UNITED STATES PATENT AND TRADEMARK OFFICE

Office Action Summary

10/784,059

GUTHLEIN ET AL.

Figure 1 - X-ray Radiator (w/ exploded sectional view) – U.S. Patent 6,084,942 to Hell et al.

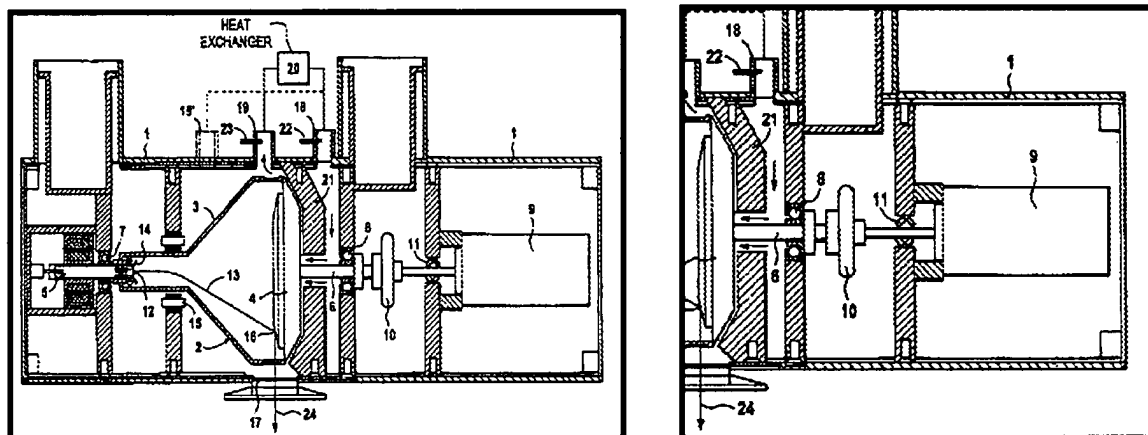
11. As per claims 1, 15 and 16, Hell et al. disclose an X-ray radiator having a rotary bulb tube (2) mounted for rotation in a housing (1) filled with a coolant (see Abstract; also column 2, lines 46-49), the rotary bulb tube being connected by a shaft arrangement (5, 6) having a coupling (10) to a means for rotating the bulb tube (9 - see also column 2, lines 43-45); wherein the coupling is surrounded by the housing and wherein the rotary bulb tube includes an anode plate (4) facing the inside of the housing (see also Fig. 1 above).

14. **As per claims 2-4**, Hell et al. disclose an X-ray radiator as substantially recited in claim 1, wherein the coupling (10) comprises an output disc (not numbered above) connected with a first shaft section (6) extending from the rotary bulb tube (2), a drive disc (not numbered above) connected to a second shaft section (not numbered above) extending from the motor (9) and an intermediate disc (10) connecting the output disc with the drive disc. Examiner notes that Fig. 1 illustrates a coupling arrangement meeting the structural limitations of claim 2. It would be appreciated by those having ordinary skill in the X-ray tube art that the disclosed coupling serves as a means of transferring rotational power from the motor (9) via the coupling element and shaft stubs (see column 2, lines 43-45). Though silent as to the material construction of the output disc, drive disc and intermediate disc, it would be appreciated by those having ordinary skill in the art at the time the invention was made to construct an arrangement whereby the shaft stubs, output disc and drive disc are formed of a metal to provide structural rigidity and performance within an elevated temperature environment. Additionally, it would have been obvious to produce intermediate disc of an insulating material such as a plastic or ceramic. One would have been motivated to make such a modification for the purpose of providing a coupling element

with insulating properties to reduce the likelihood of thermal transfer between coupled elements as well as the buildup of static charge resulting from rotating components. A benefit of such arrangement would result in a reduction of wasted heat, whereby natural convection could be exploited to transport heat away from the tube as suggested by Hell et al. (column 1, lines 12-20).

15. **As per claim 13**, Hell et al. disclose an X-ray radiator wherein the second shaft section is directed through a gap in the housing and provided with a seal (**11** - see Fig. 1, above).
